Re: Tentative Map, Conditional Use Permit, Tree Removal, Design Review

File: 2023-078

Please see items in Red in response to your letter of March 6, 2024, Kathy Austin

PACIFIC KNOLLS

SHEET C1.00

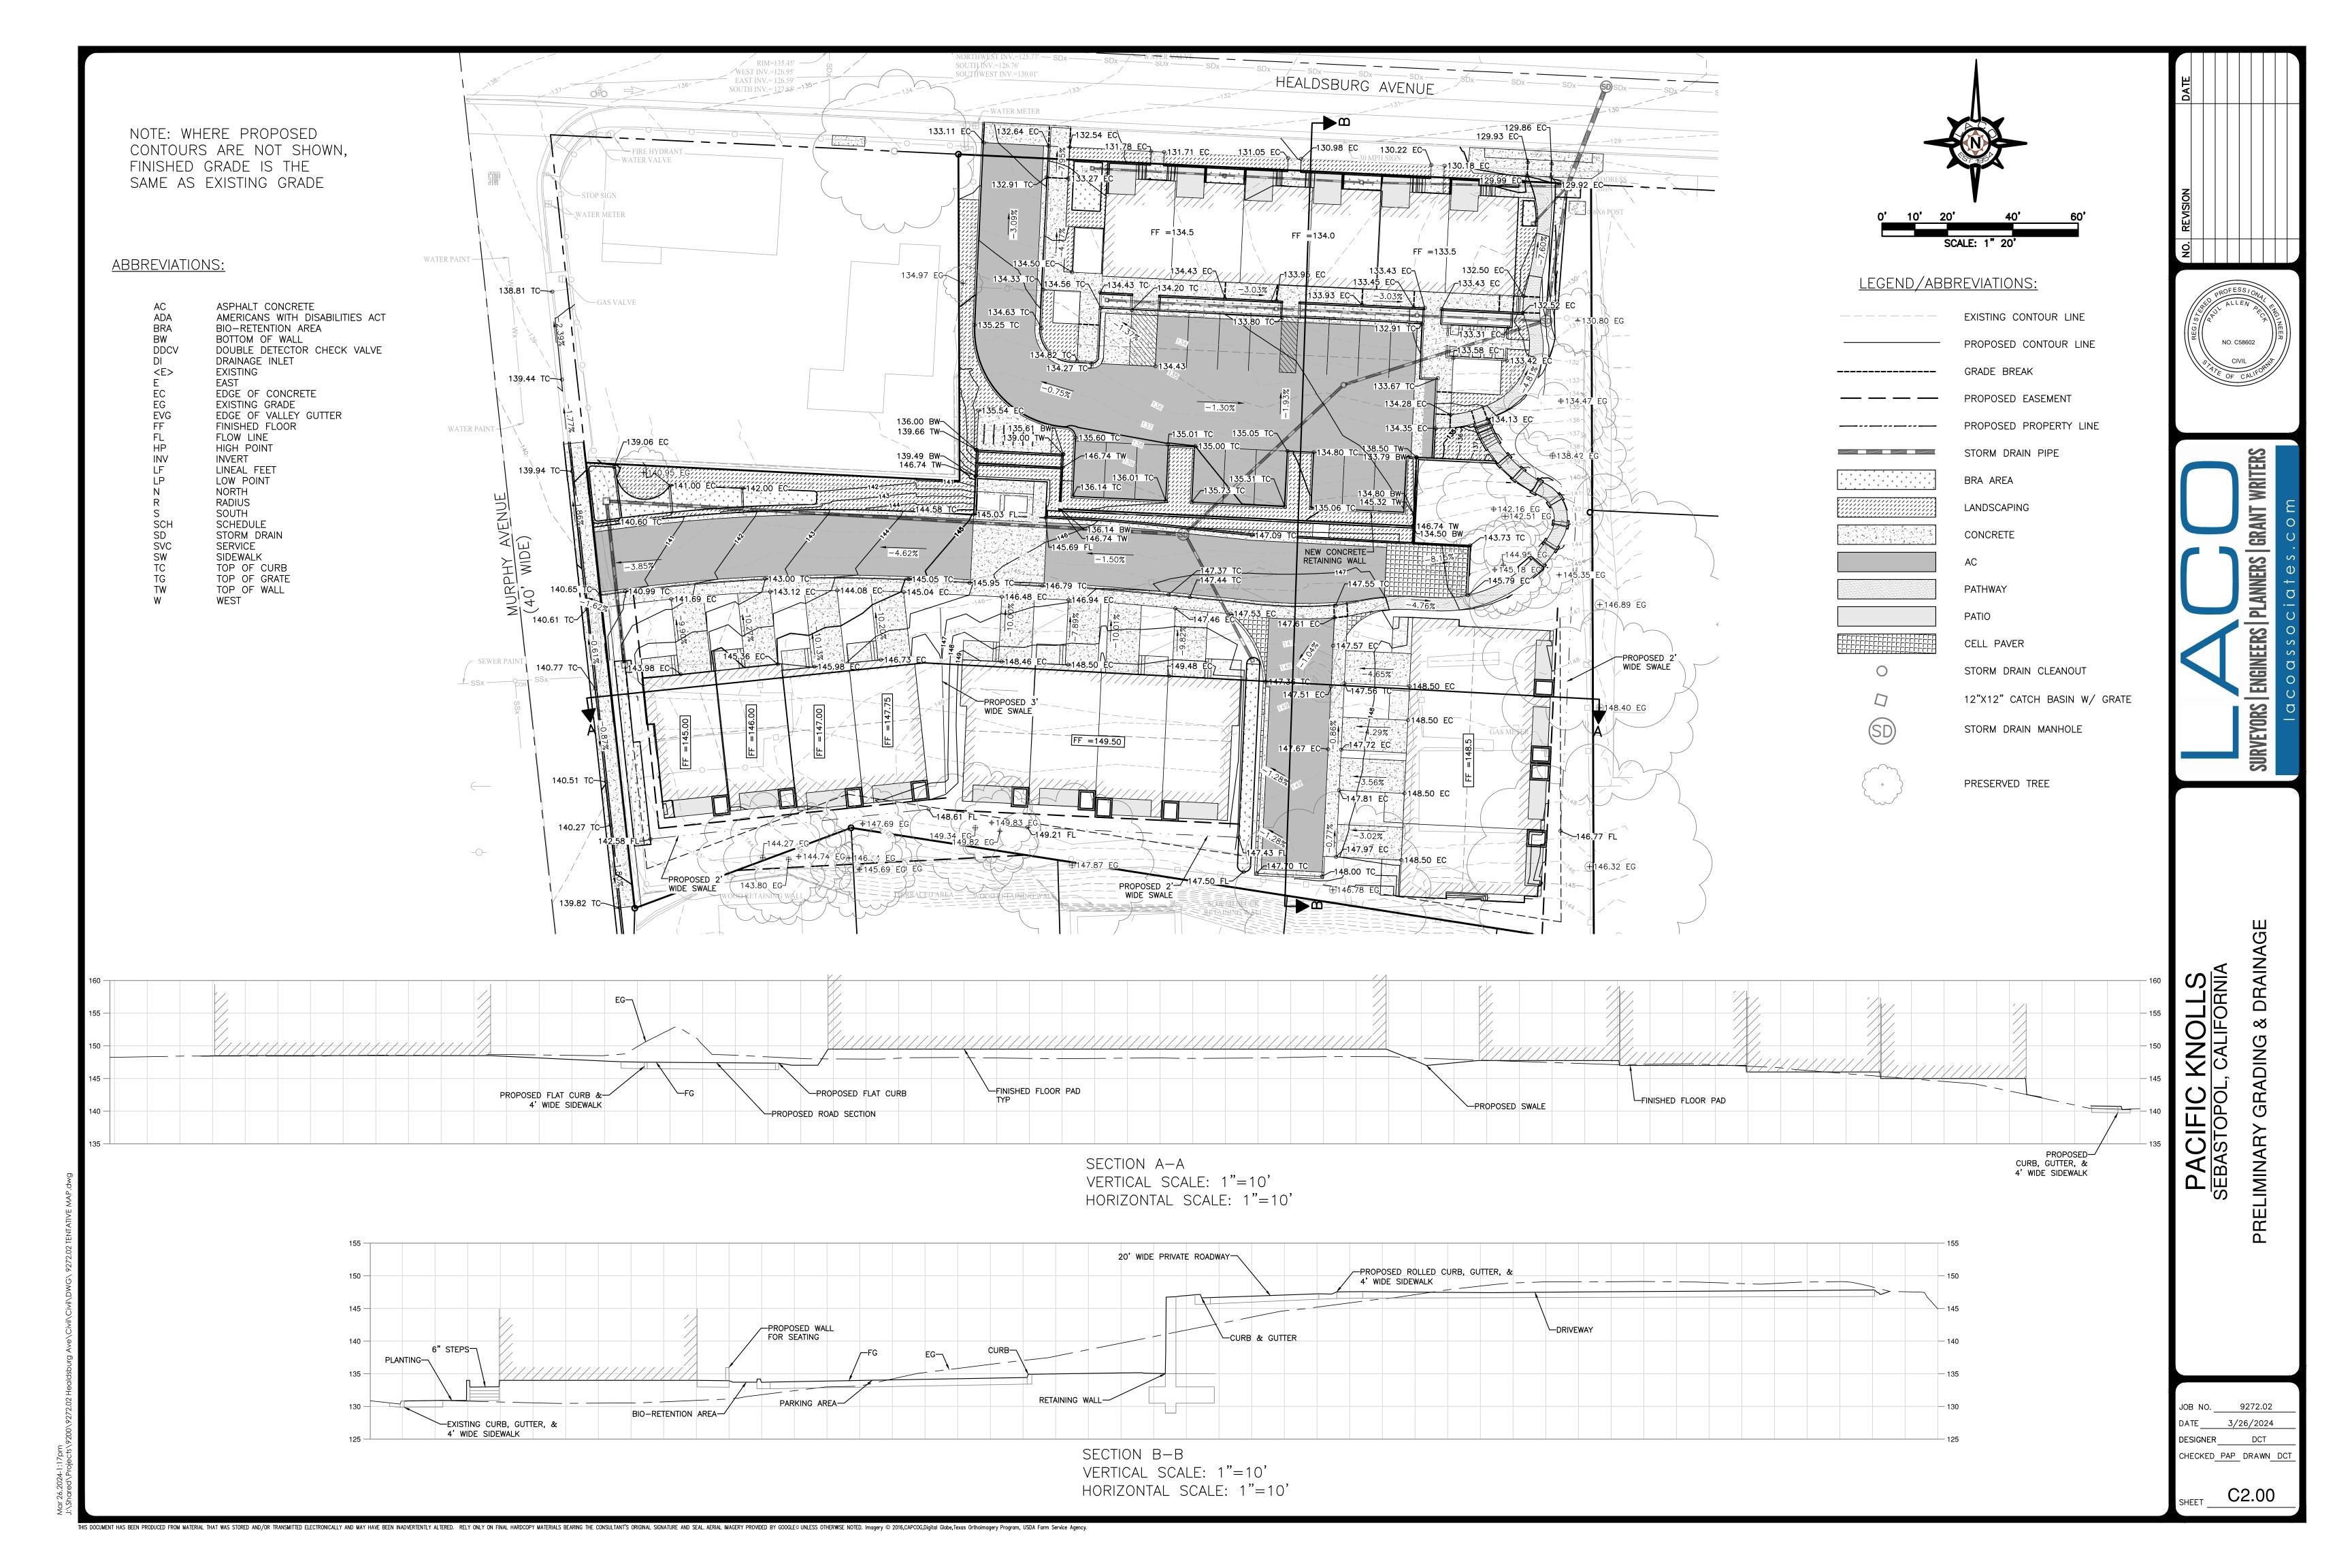
- 4. The rear corner of Building 4 is located within the rear setback. As discussed, this is part of the storage shed at the back of the home. It is approximately 8' high and not part of the conditioned space. We can cut it back but would prefer to ask the PC to allow it as we are planning on getting an easement in that area to keep the fence where it is and use that area as yard.

- 6. Building setbacks for lots 9-12 appear to have the wrong setbacks shown. These are correct. The orientation of the lot is per individual lot not existing single lot. The rear setback is 10'

- 7. Lot 12 appears to show insufficient turn radius to back out of driveway. As well as# parking spaces 9 and 18 along the Healdsburg Ave building. The dimensions are based on the parking lot requirements in the Sebastopol Zoning Code. They are sufficient without the need for a turn out. They should comply.
- 8. Survey is missing information on Calder Creek (location, top of bank, etc.), which runs# along the southern portion of the property. Please provide this as part of the survey to# ensure that the buildings are not located within any creek setbacks. Neither Calder nor Zimpher Creeks are near the site. This direction is incorrect.

Apartment Building Elevations NTS

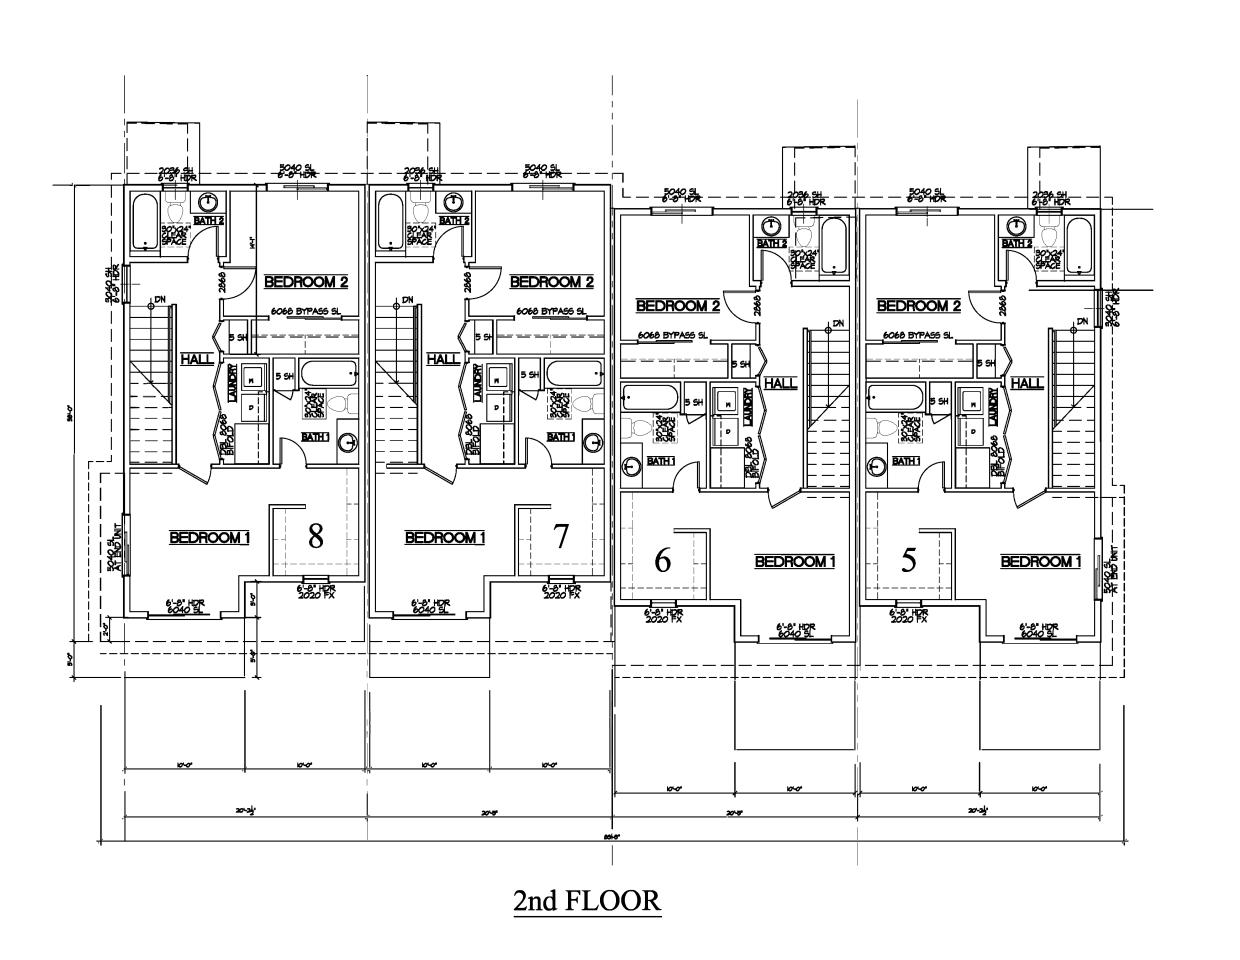
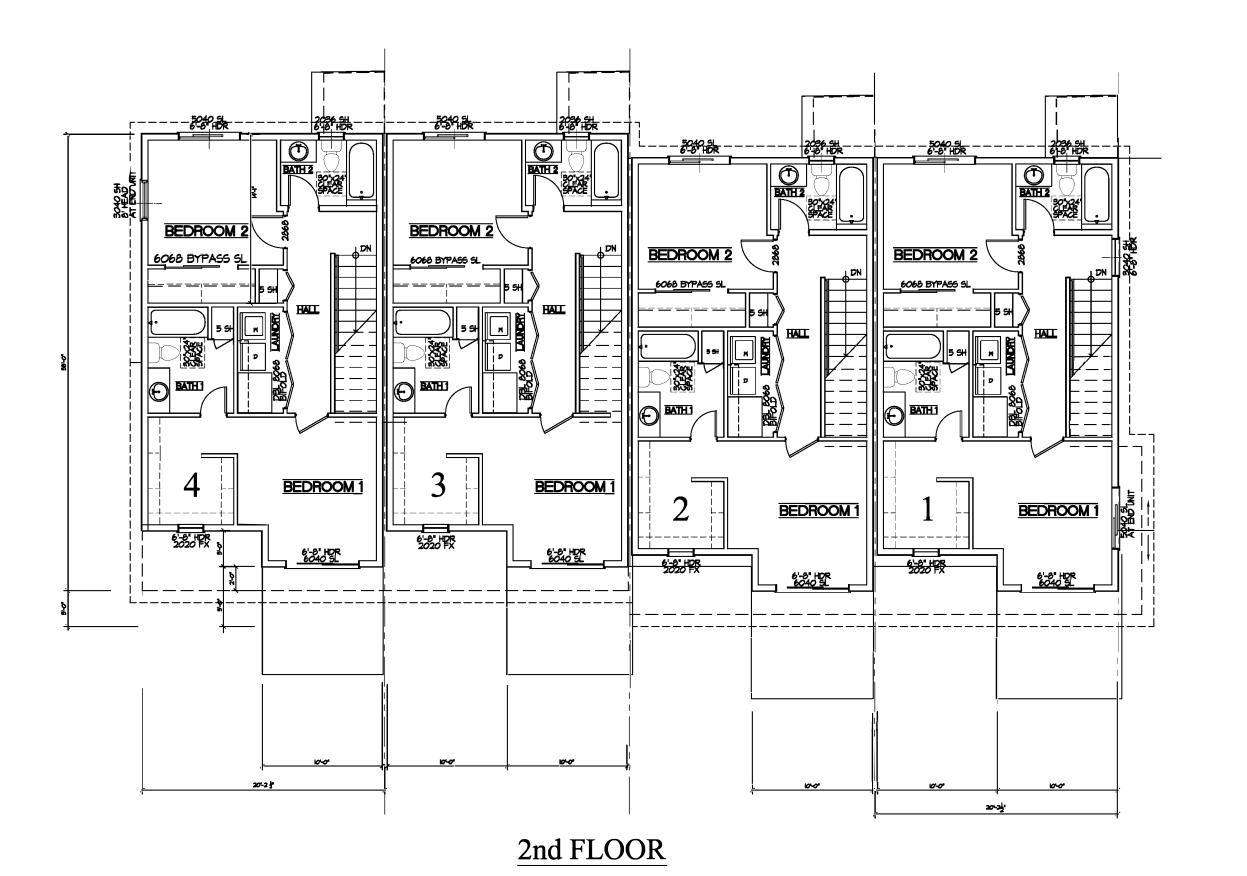
- 5. Elevation pages do not show scaled building height dimensions. Heights have been added to the elevation sheets along with verbiage describing the heights and floor to floor heights. The drawings are not to scale as they are based on a 3D model.

Note: Drawings are not to scale. Maximum Height at middle parapet is 29' +/- Building steps 6" at each color change to work with slope to minimize height. At no point will the building exceed 30' in height. Floor to floor height is 10' at west end and 11' at east end. Parapet is 3' on east and west, 4' at center. Site slopes in both east and west and north and south direction. Maximum foundation height is 4' on north east and 3' on north west to provide ADA access on the south side.
